Author's response

Dear Editor and Dear Referee #1,

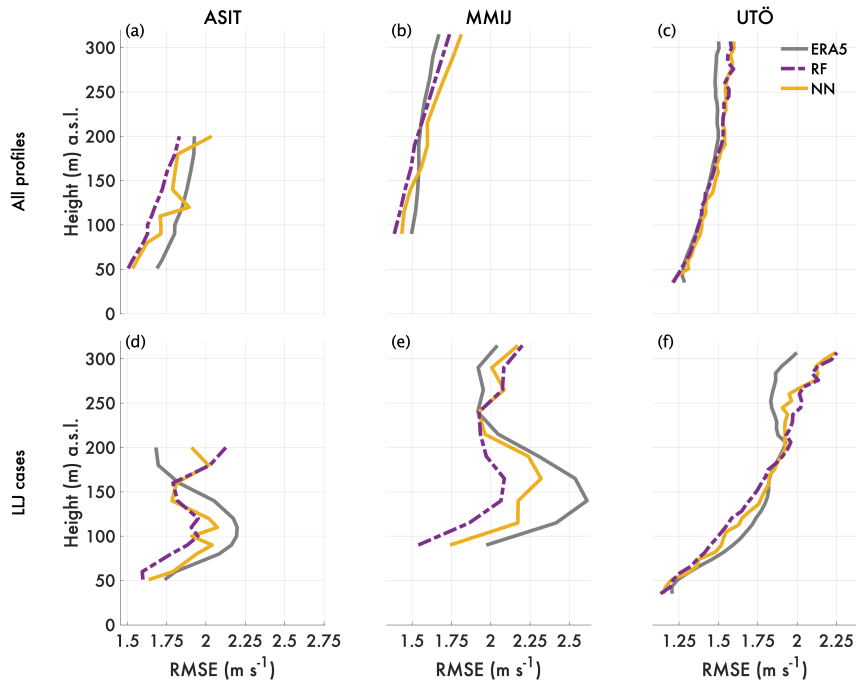
P21L407: You write "In particular, both the RF and the NN generally result in lower RMSE than ERA5 at typical offshore hub heights when compared to the ground truth lidar profiles.", but that does not seem true to me at Utö. Looking at Fig. 6 it seems to me the RF model is on par with ERA5 at relevant hub heights, and NN is worse than ERA5. The same can be set for the NN method at ASIT.

Thank you for noticing this. We have changed the text in the Discussion which now reads (line 425–428):

For both ASIT and MMIJ, the RF and the NN result in lower RMSE than ERA5 in the lower half of the height range swept by the turbine blades (hub height and down) of a typical modern offshore wind turbine, when compared to the ground truth lidar profiles (Fig. 6). For Utö, the performance of the ML models is similar to that of ERA5.

We have also re-plotted Fig. 6 in the manuscript to present the results in a clearer way, please see Fig. R1 below.

Figure R2: Predictor importance for 10 random splits of the time series as calculated by the RF for the measurement height 140 m (ASIT, MMIJ) or 152 m (Utö). The results are for the validation period.

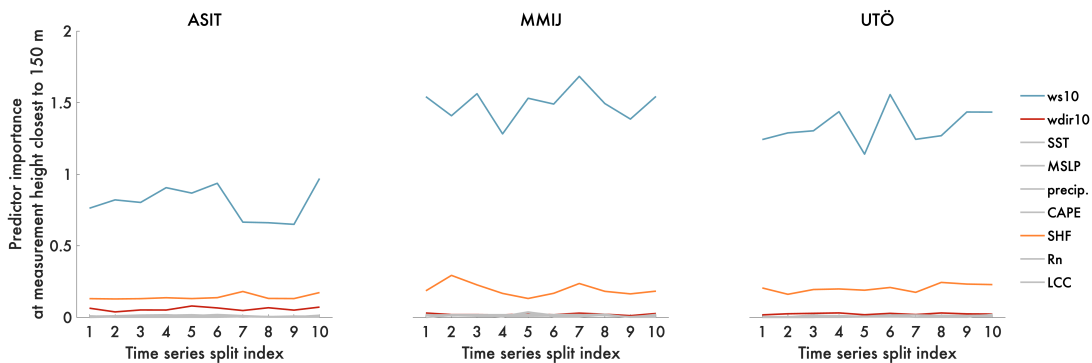
You did a good job of splitting the data into training, testing, and validation data and taking care of the data stratification (seasonality) and correlation (excluding data between sets). However, you could do more to investigate the sensitivity of the results to the splits, e.g. you could have done a k-fold cross-validation of the training+testing data (adjusting exclusion data each time) and presented the robustness across folds. This would also give you a better sense of the robustness of your predictor importance analysis.

The robustness of the predictor importance is a very important remark. We have tested the sensitivity of the results on the predictor importance by re-running the RF for the WSPE regression task, testing 10 randomly created splits of the time series for each of the three sites. The first split of the time series (index 1) is the same that was used for the results presented in the manuscript. In Fig. R2, the predictor importance for all predictors at the measurement height closest to 150 m (140 m for ASIT and MMIJ, 152 m for Utö), which is a typical hub height for modern offshore wind turbines, is presented. Results are for the validation period just as in Fig. 5 in the manuscript, but look similar also for the test period.

As seen in Fig. R2, there is some variation in the predictor importance for the different predictors across folds. However, the general conclusions remain that, for all sites, the ws10 is by far the most important predictor for the wind speed higher up, followed by the SHF. For ASIT, the wdir10 also has slightly higher predictor importance than the rest of the predictors, while for MMIJ and Utö it is of similar (un)importance.

Further, to test the robustness of the method and the sensitivity to the data split (Fig. 3) the time series have been randomly split into training, validation, and testing ten times for all sites. Then the RF has then been trained according to the protocol described in Sect. 2.5 and the predictor importance calculated. Results from this sensitivity analysis (not shown) clearly separates the ws10 as the most important predictor across all folds and for all sites, and SHF as the second most important predictor.

Figure R3: Comparison of RMSE differences (RF minus ERA5) in the WSPE regression task for the test and the validation period for all ten random data splits.

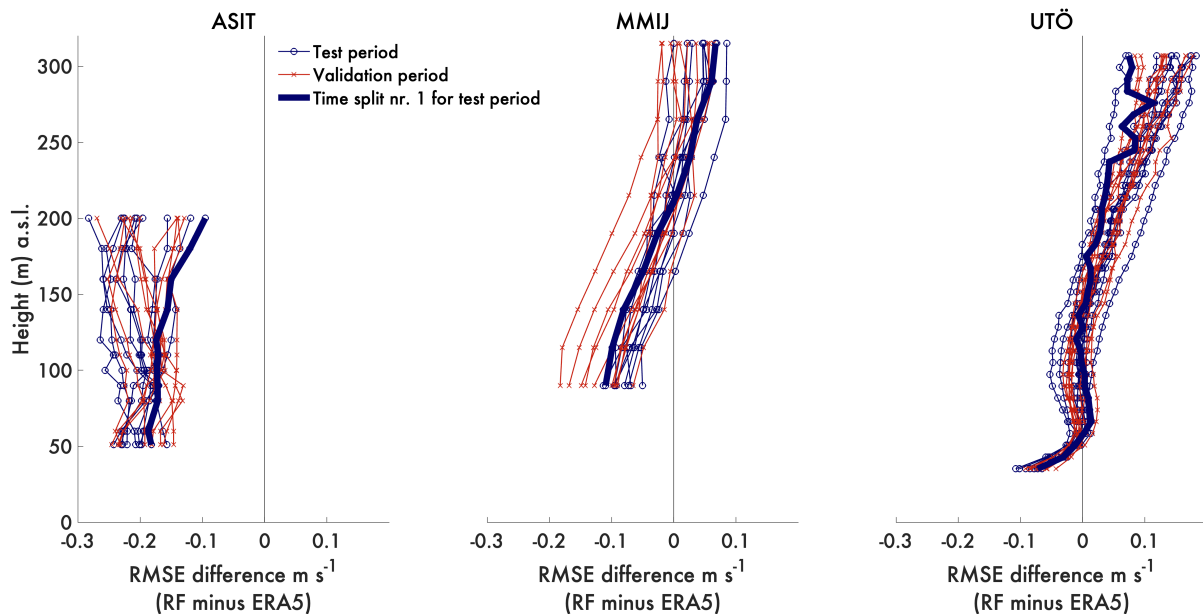
In the same spirit as the question above, it would also be interesting to know more about how testing and validation results differed.

In Fig. R3, we have plotted the RMSE difference (RF minus ERA5) for the WSPE task for the ten folds of the time series previously described. Negative numbers implies that the RF performs better than ERA5 (lower RMSE), and vice versa for positive numbers. We see that, for all three sites, the results for the test period and the validation period generally resembles each other, although there is of course some variation comparing different folds. For MMIJ the results for the validation period are generally associated with greater improvements than the results for the test period, but for ASIT and Utö differences are smaller and the performance in the test and validation periods more similar. The thick lines in the plots, marking the results using time split number 1 for the test period (which are the results presented in Fig. 6 in the manuscript) are more-or-less close to the middle of the distribution of the results for the test period for MMIJ and Utö, but slightly shifted to the right (lower performance of the RF) for ASIT. Thus we claim that the results presented in the manuscript are representative for the method, or at least not indicating results that are better than the average.

In the same sensitivity test described above, running the RF for ten random splits of the time series at each site individually, the RMSE profiles are similar to what is presented here, and for ASIT even showing slightly larger reductions on average.

Figure R4: Wind speed distribution at the height level closest to 150 m. The results presented are for the test period.

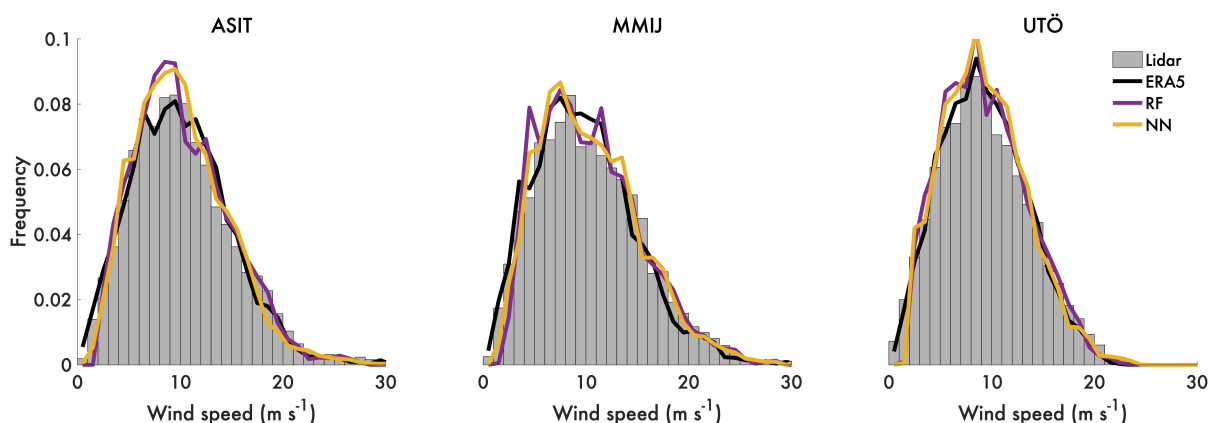
You evaluate the wind speed profile with the RMSE. The same metric your ML models are optimized for. For the methodology to be truly and generally valuable, I would consider it important to see improvements or at least no major degradation, for other statistics as well. For example, you spend some time in the introduction emphasizing the importance of correctly modeling the shear affecting the rotor. Why not show how well the shear is estimated by your ML approach? A second thing you could also consider is how well distributions are modeled. These ML methods are good mean-finding methods for different conditions. This may give you a low RMSE, however, this can come at the cost of narrower distributions that greatly underestimate the average power density.

Thank you for sharing this concern. We are aware of this problem and agree that one should be very careful assuming that the output from ML models, not only performs better for the metric it was optimised for, but also in every other aspects. Our only goal with the WSPE regression task is to improve the RMSE for wind speed profiles. As the ML models are optimised using all wind profiles in the validation period, it was expected that there should be an improvement for the general wind profile in the test period, but not necessarily so if an LLJ (which to some extent can represent an extreme case of a wind speed profile) was present. We strongly suggest to optimise the ML models for the main topic of interest. If "everything" is of interest, then multiple verification metrics could be included in evaluation and optimization of the models. In Fig. R4, the wind speed distribution at the height level in the data closest to 150 m is plotted for the lidar, ERA5, RF, and NN for the three sites. As seen in the figure, ERA5 is better at representing the full distribution, especially at ASIT and Utö, while the ML models tend to overestimate the peak of the distribution. With your comment and this figure in mind, we have added the following sentences in the revised version of the manuscript (lines 432–438):

However, it should also be mentioned that – as the ML methods applied here focus on reducing the RMSE – there is a possibility that the quality of the prediction is inferior in other aspects when compared to ERA5. For example, analysing the wind speed distributions at 150 m height for the three sites (not shown), ERA5 better represents the full distributions while both RF and NN tend to underestimate the extremes and overestimate the peak of the distributions. This could have further implications, e.g., in non-linear calculations such as in estimations of the power production. We strongly recommend to optimise the ML models using the metric (or combination of metrics) that are of importance for the application, and to be aware that an improvement for one metric does not necessarily result in an improvement for all other metrics.

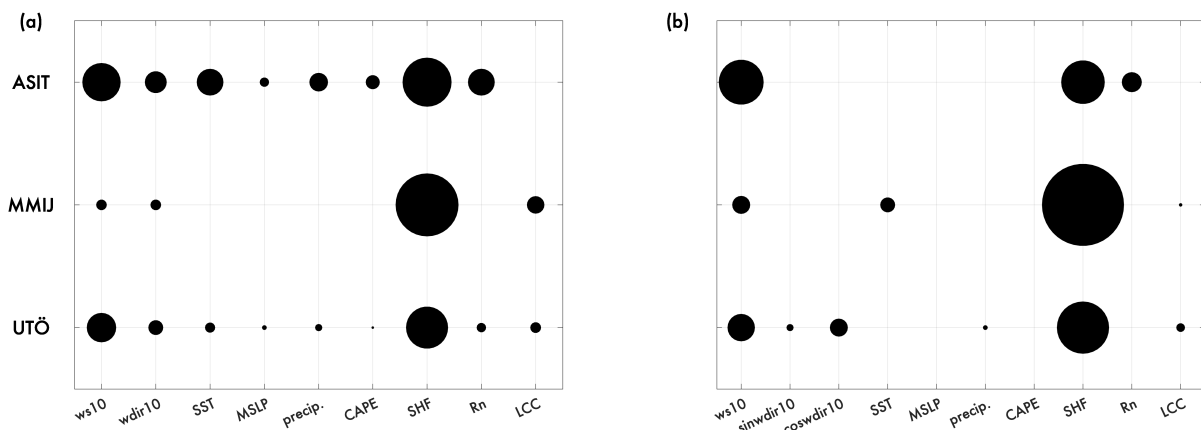
How did you treat/encode the circularity of wdir10 in the ML models? it is not clear to me if you used any kind of encoding, e.g. sin and cos transformation

You state in your introduction that an important mechanism for LLJ-gensis is warm air advected over cold water so I would assume wind direction to be of some importance (given that the sites are coastal). However, wdir10 appears to be of minor importance (perhaps a bit more important at ASIT). I think it would be good to explain or at least discuss this more. I'm wondering if it's connected to the question of encoding of circularity and the fact that at least ASIT and Utö clearly have land to the North. In both cases, encoding wind direction from 0° to 360° clockwise from North would make it difficult, e.g. for the decision trees, to split land directions from sea directions (since land directions are at both tail-ends).

Thank you for noticing this. Coming back to what we explained in our reply to the previous question, the results for the predictor importance has been recalculated with the RF using the sine and cosine encoding and results are presented in Fig. R5. For comparison, also the results achieved when using 0–360° for the wind direction are included (panel a). As seen in the figure, introducing the sine and cosine transformation of the wind direction changes which predictors that are selected in training the RF. For example, for ASIT, all predictors (except LCC) are included if wdir10 is used, but only ws10, SHF, and Rn are included if $\sin(\text{wdir10})$ and $\cos(\text{wdir10})$ are used.

Concluding from Fig. R5, the statement in the manuscript that SHF is the most important predictor in LLJ prediction still holds, and also that it is followed by ws10. It also seems that the new encoding of the wind direction does not help to dramatically increase the predictor importance of the wind direction. The relatively low importance of the wind direction is interesting, because – as you mention – the warm air advection over relatively cold water in spring/early summer is one of the main explanations for LLJ formation. However, it is important to note that warm air advection over cold water results in stable stratification and a change in SHF. Since the same wind direction not necessarily result in stable stratification and good conditions for LLJ formation in other seasons, the SHF is a much better predictor than the wind direction.

Note that, throughout this study, the wind direction (wdir10) was included as values in the range 0–360°. Using the sine and cosine encoding of the wind direction to better handle the circular coordinates of the variable was tested for the analysis of predictor importance in binary predictions of the LLJ using the RF method, and although this representation causes minor differences in predictor importance, the main

conclusion that SHF and ws10 are the most important predictors still holds. It is also worth noting that, although warm air advection over relatively cold water in spring and early summer, creating stable conditions, is often mentioned as one of the key formation mechanisms for offshore/coastal LLJs, it is the stability of the atmosphere rather than the wind direction that is the win direction itself that is most important, i.e., the SHF is more important than wdir10 (no matter the encoding) for LLJ prediction.
